TO: Jennifer Fitch, PE Project Manager Vermont Agency of Transportation	DATE	PROJECT NO.
	9/26/2014	Brookfield BRF FLBR (2)

COPIES	NUMBER	DESCRIPTION	CODE
1		FRP Fabrication NCR 11 - Pontoon 7 - Stiffener Plates	H

**Brookfield BRF FLBR (2)**

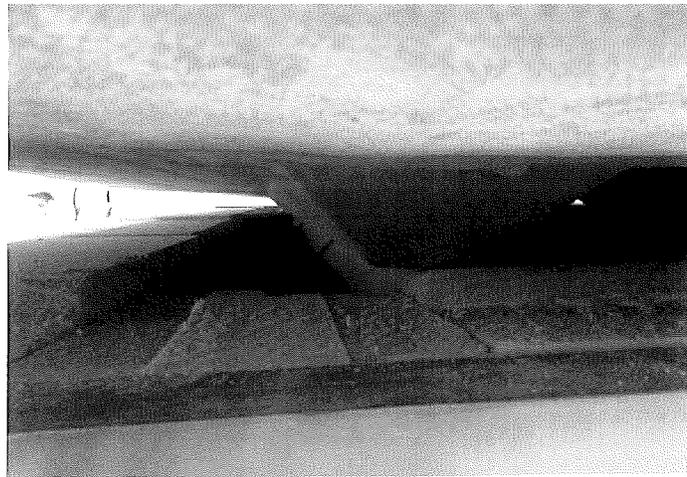
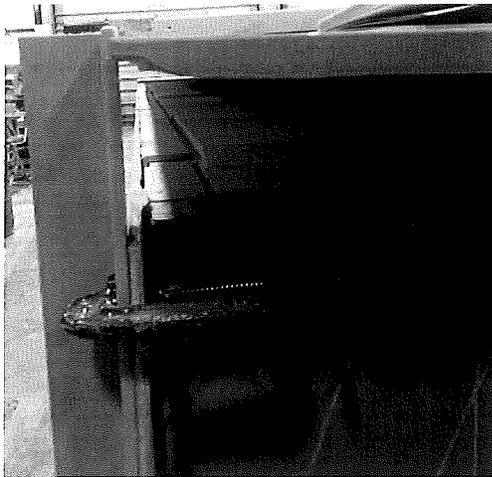
On September 26, Kenway identified an error in the stiffener location of top plate 7b. The technician placing the stiffener performs measured from the wrong side of the panel resulting in the stiffeners being shifted 6 in. from the intended location.

The figure on the left shows the top panel lined up with the outside surface of the vertical wall. The figure on the right shows the center of the stiffener landing on the edge of the beveled foam blocks. The length, width, and height of each stiffener is correct.

Kenway plans to cut 6 in. off the edge of the foam blocks that interfere with the stiffener at the same 45 degree bevel. These pieces will be placed on the opposite side of the recess to restore the gap in the foam to the intended width.

Shown below are two sets of calculations. The first set presents the original buckling calculation for the top plate with an unsupported width,  $b$ , of 30.25 in. The second set shows the same calculation with the value for  $b$  increased by 6 in. for a total of 36.55 in. The buckling resistance is still satisfied even with the shifted stiffeners.
